Submissions report

SSD-78493518

2-8 Highgate Road, Lindfield

CPDM Pty Ltd

Figure 1: Excerpt of the Building Separation Plan Level 8

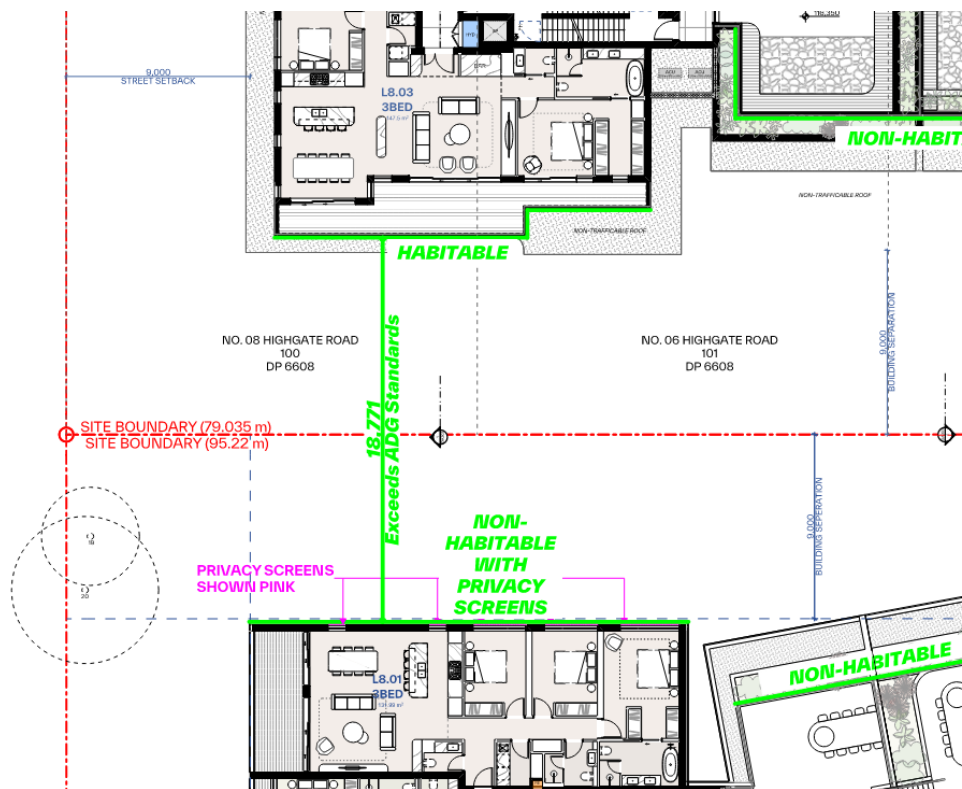
<p>KC-52</p>	<p><u>Building separation</u></p> <p>The proposed building separation to the western side boundary appears to be approximately 9.6m at the ninth storey (balcony of unit L8.03) [DA110 01 and DA300 01]. This does not meet the requirements of ADG 3F-1 for a building separation of 12m for habitable rooms and</p>	<p>Updated Architectural Plans (Appendix A) reduce the building footprint at Level 1 and Levels 2–8 along the western edge to increase separation to the adjoining TOD site. While the numerical ADG 3F-1 distance is not fully met, visual privacy and amenity are managed through the stepped upper form, façade articulation, privacy screening and planting.</p>

The Apartment Design Guide (**ADG**) establishes minimum building separation distances to protect visual privacy, minimise overlooking, and maintain reasonable residential amenity, while allowing flexibility through a performance-based assessment where the underlying objectives are achieved by alternative design responses.

Unit L8.03 at Level 8 is a habitable apartment with primary living spaces and a balcony oriented toward the adjoining development (SSD-79261463) containing Unit L8.01.

In this instance, the interface with Unit L8.01 is not a habitable-to-habitable relationship. Unit L8.01 is designed as a screened, non-habitable interface through the permanent installation of fixed privacy screens to the external openings. These screens substantially restrict views, prevent direct overlooking and remove any reasonable expectation of reciprocal outlook toward Unit L8.03.
